ACCESS VALVE REPLACEMENT FOR 22", 30", AND 48" ICE MACHINES

Installation Instructions

Process valve, Manitowoc part number, 8373103, is no longer available from the manufacturer. Substitute access valve, Manitowoc part number, 8373263, supplied in this package

Access valve shown installed in 22" ice machines

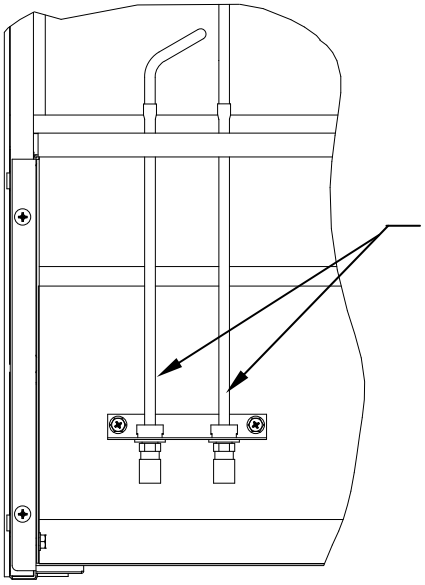
Installation instructions for Manitowoc 22" ice machines:

1. Remove refrigerant from ice machine or use pinch-off tool to isolate the valves from the refrigeration system.
2. Cut the 1/4" diameter tubing.
3. Remove process valve.
4. Install access valve.

Access valve shown installed in 30" and 48" ice machines

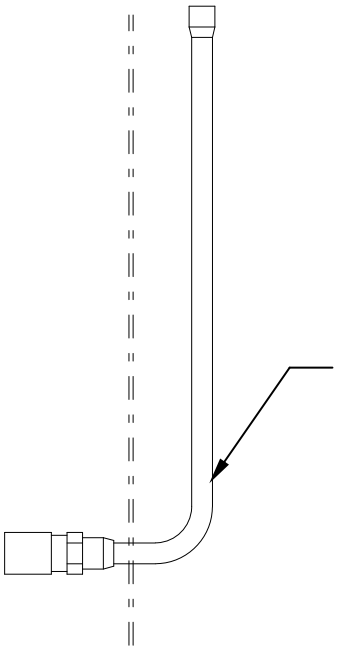
Installation instructions for Manitowoc 30" and 48" ice machines:

1. Field bend 90° new access valve. Valve may protrude through bulkhead more than existing valve.
2. Cut existing tubing to proper length.
3. Remove existing valve.
4. Install bushing in bulkhead hole.
5. Braze in replacement valve.
